# STATE OF VERMONT AGENCY OF TRANSPORTATION

### TOWN OF FAIRFAX COUNTY OF FRANKLIN VT. RTE. 104 MINOR ARTERIAL BRIDGE NO. 10

RECORD PLANS	
CONTRACTOR	BLOW & COTE INC - MORRISVILLE, VT
RESIDENT ENGINEER	GREG WILCOX
CONSTRUCTION BEGAN	OCTOBER 5, 2009
CONSTRUCTION COMPLETE	SEPTEMBER 10, 2010
RECORD PLANS BY	GREG WILCOX & M. BIRCHARD
I HEREBY CERTIFY THAT ALL THE CONSTRUCTION REQUIRED BY THIS SET OF DRAWINGS HAS BEEN ACCOMPLISHED AS INDICATED HEREIN	
BY	RESIDENT ENGINEER
DATE	3/3/2011
NOTE Any further information concerning final quantities, amounts or other details relative to this project may be found at Central Files in the electronic archives

Fairfax BHF 023-1(5)  
Record Plans

**ABUTMENT I DETAILS**

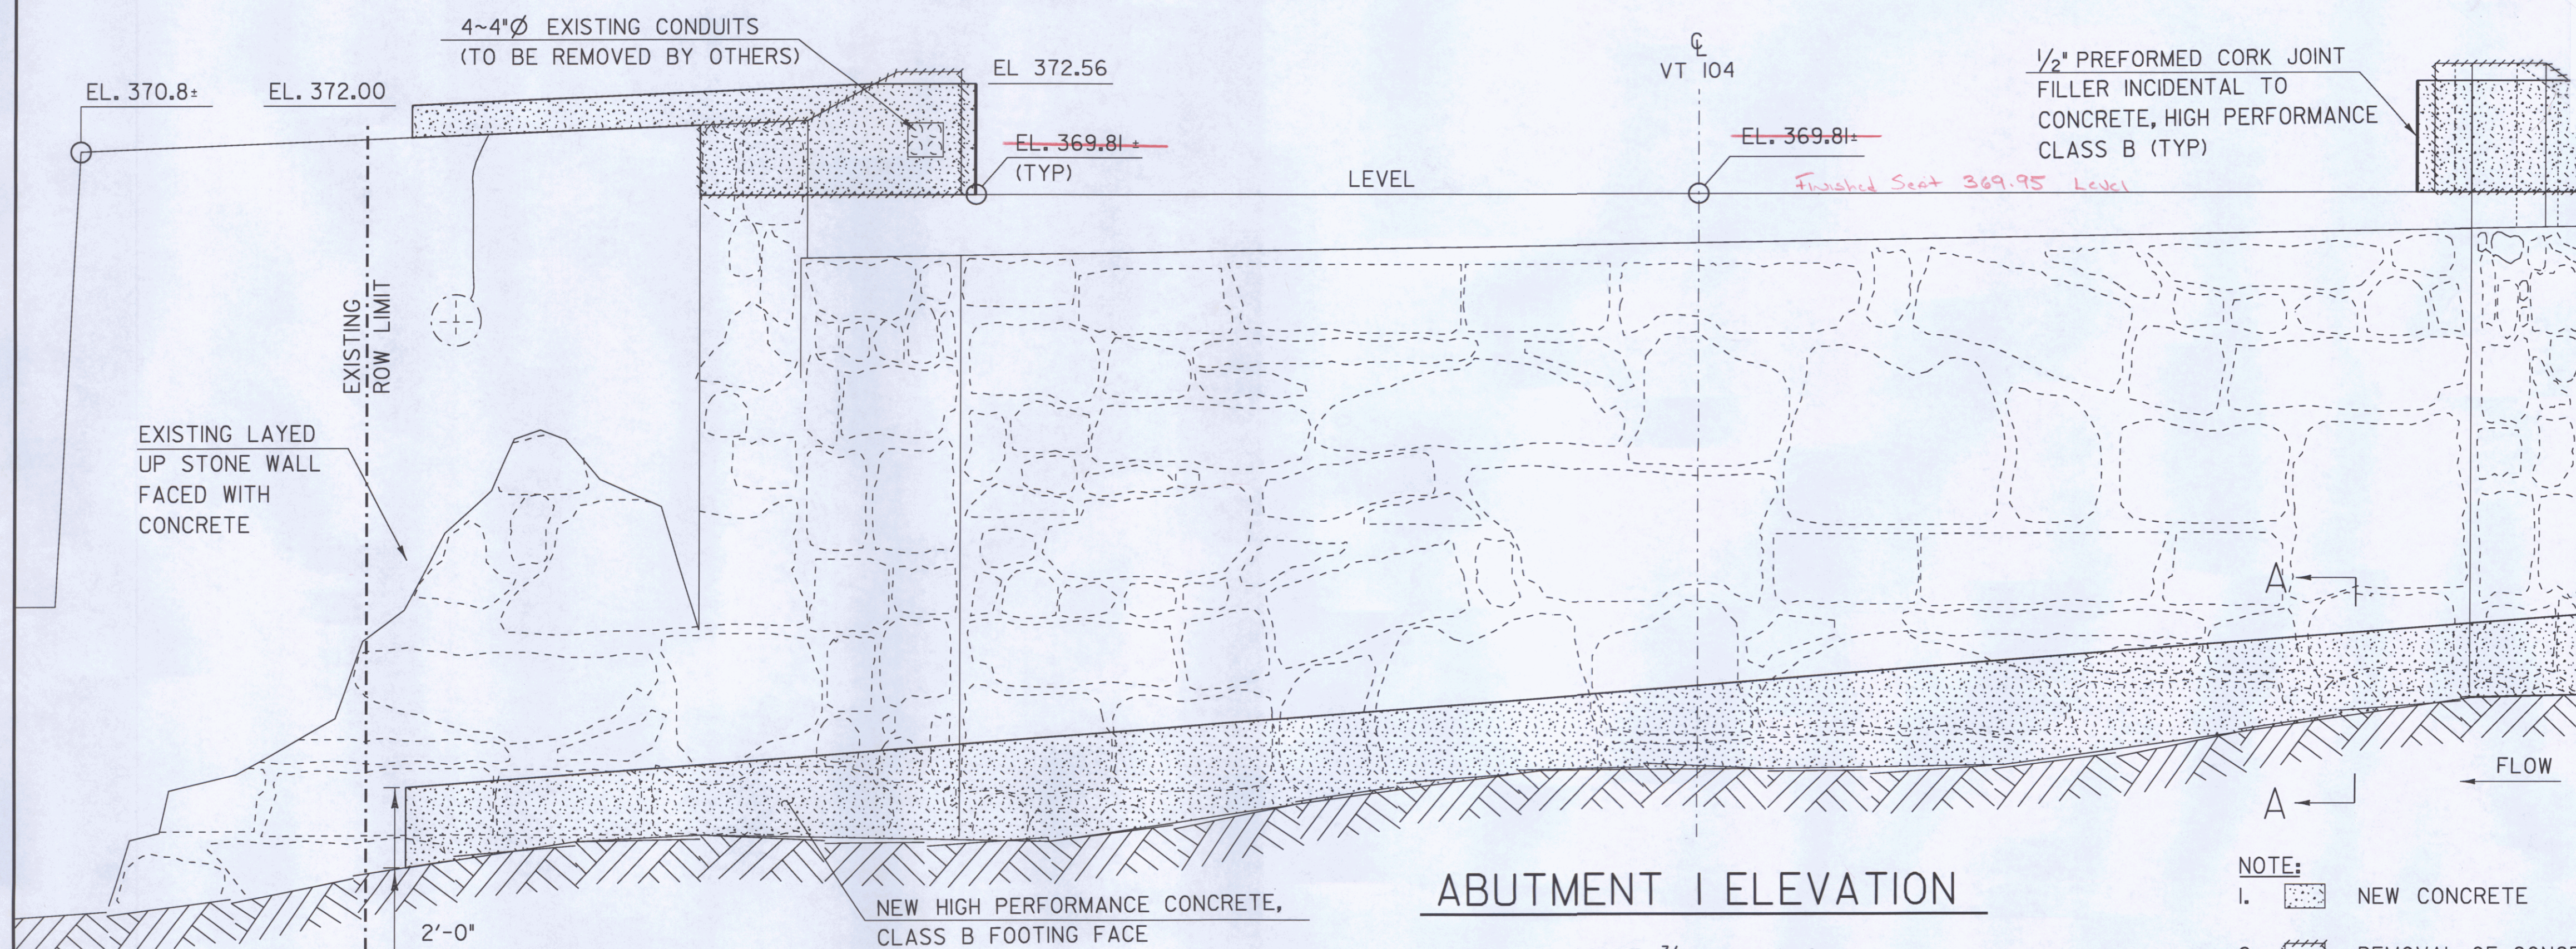
(A) (10' x 45') = 450 sq'	(A) 12' x 1' = 12 sq'
(A) (24' x 18') = 432 sq'	(A) 12' x 5' x 1/4 = 15 sq'
(A) (5' x 16') = 80 sq'	(A) 16' x 8' x 1/2 = 40 sq'
(A) (6' x 16') = 96 sq'	(A) 22.5' x 8' = 180 sq'
(A) (10' x 30') = 300 sq'	121 sq' 2
(A) (8' x 15') = 120 sq'	121 sq' 10
(A) (33' x 9') = 297 sq'	(A) & (A) Values show agreement with equation
(A) (8' x 5') = 40 sq'	This reports the % of Area from Above
	Scale that was carried out #900.675
	9/11/11

To Bk #3, p. 64  
STW 12-16-10

ABUTMENT 2 PLAN

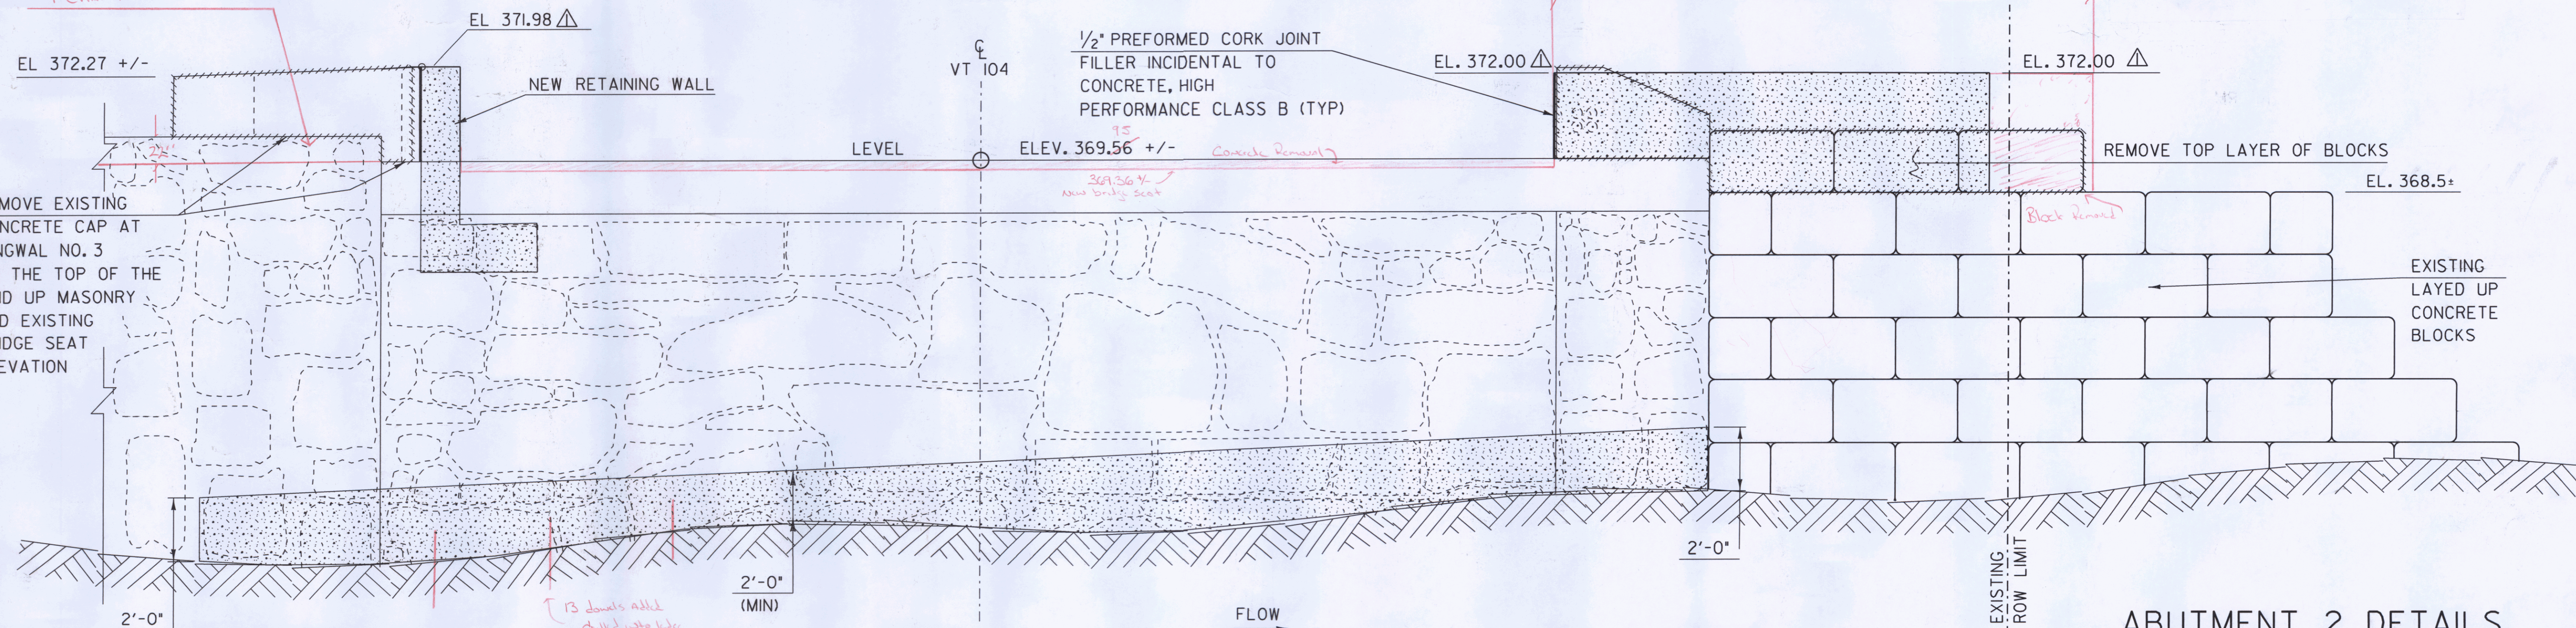
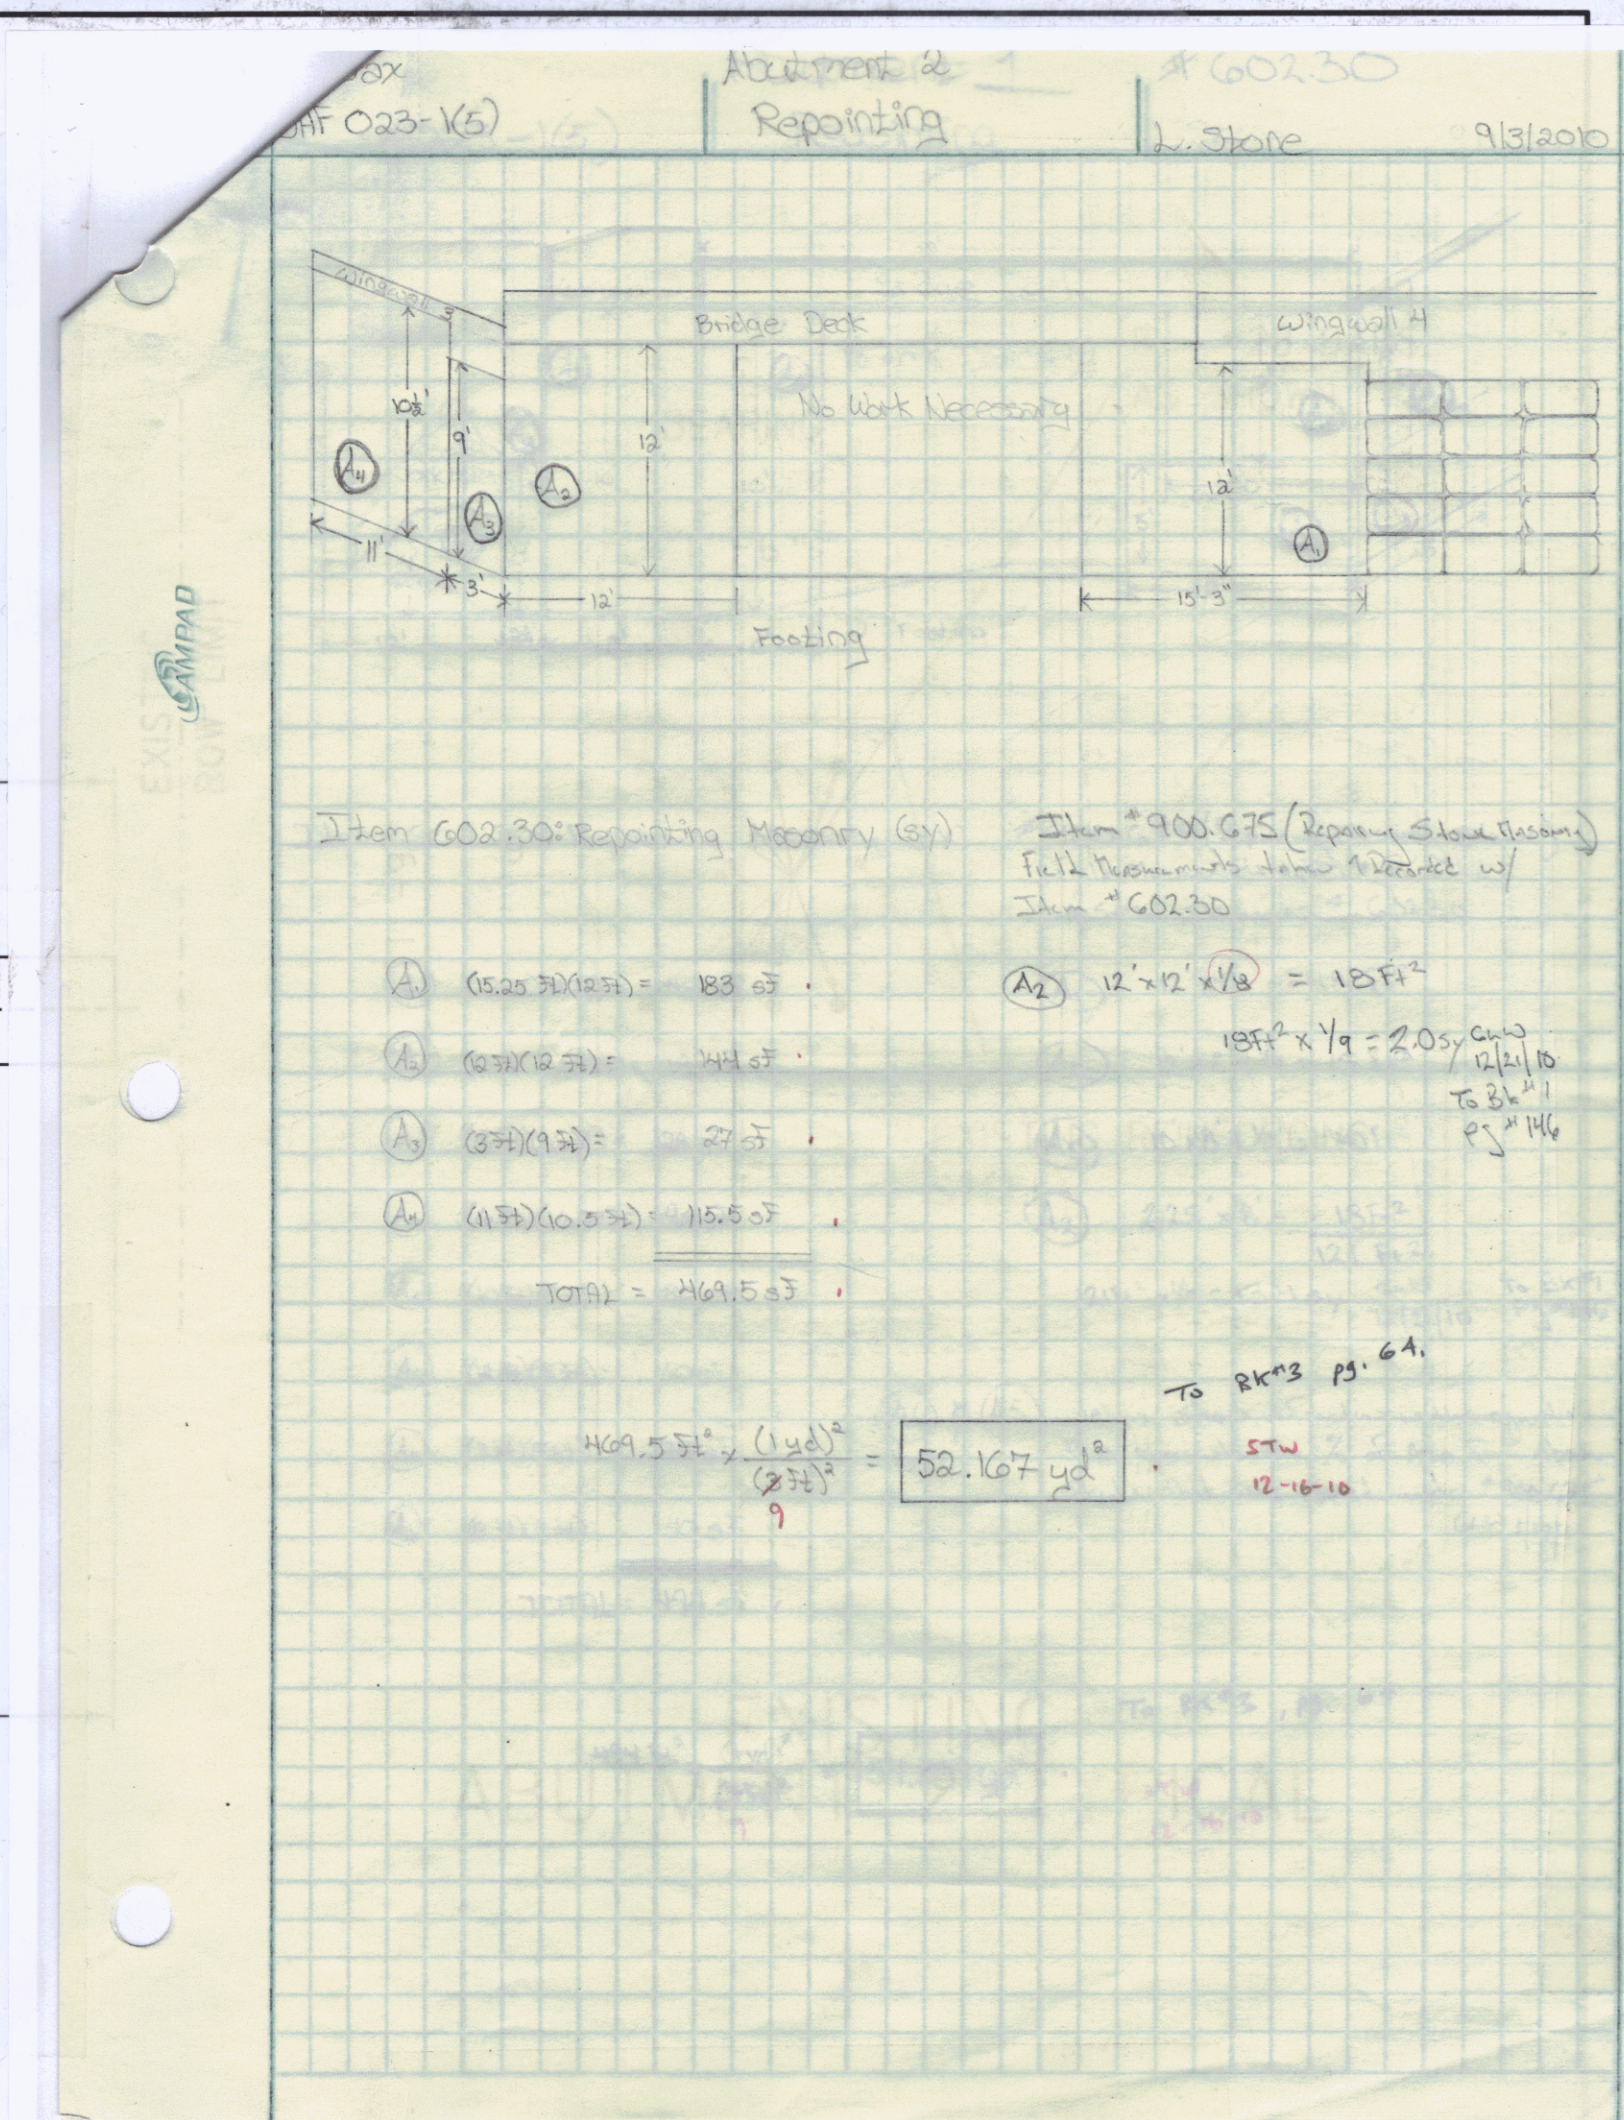
Additional Masonry Removal. HRC-B cap poured back as a full part of base for 4' Chaw hole Face

REVISION NUMBER	DESCRIPTION	DATE
1	CHANGE DUE TO FIELD CONDITIONS	10/30/09
